Title		
Size: A	Number	Revision
Date: 1/25/2024		Sheet of
File: C:\Users\..\Power_Section.SchDoc		Drawn By:

Title		
Size A	Number	Revision
Date: 1/25/2024	Sheet of	
File: C:\Users\..\Transmitter_Receiver_Section.SchDoc	Drawn By:

100V BOOST REGULATOR

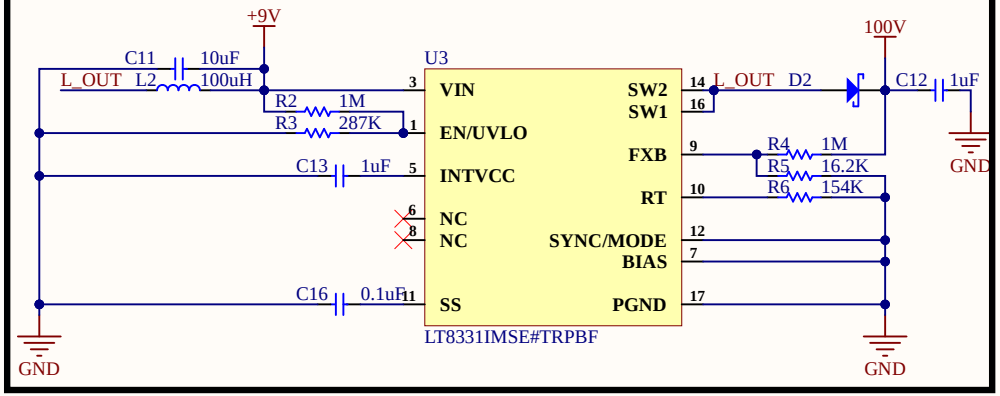
LT8331EMSE#TRPBF is out of stock from lcsc, may I used alternates [LT8331IMSE#TRPBF](stock = 105)
The Differnece between them is Operating juction temperature.

Connections in given schematic were different from reference schematic for R2 and C13.
Reference schematic from datasheet is followed for R2 and C13 connection

TRANSMITTER CIRCUIT

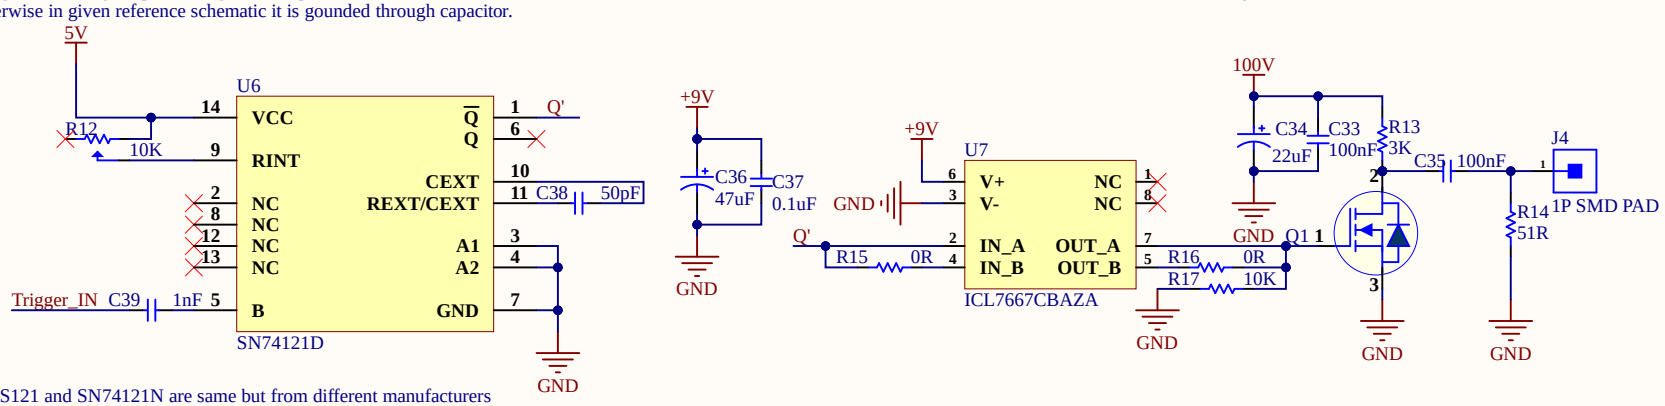
Trigger_IN through capacitor is given to input B,
otherwise in given reference schematic it is gounded through capacitor.

3kOhm (0.25W), 10kOhm (0.25W) and 50Ohm (1W) Required ratting mention in link

74LS121 and SN74121N are same but from different manufacturers
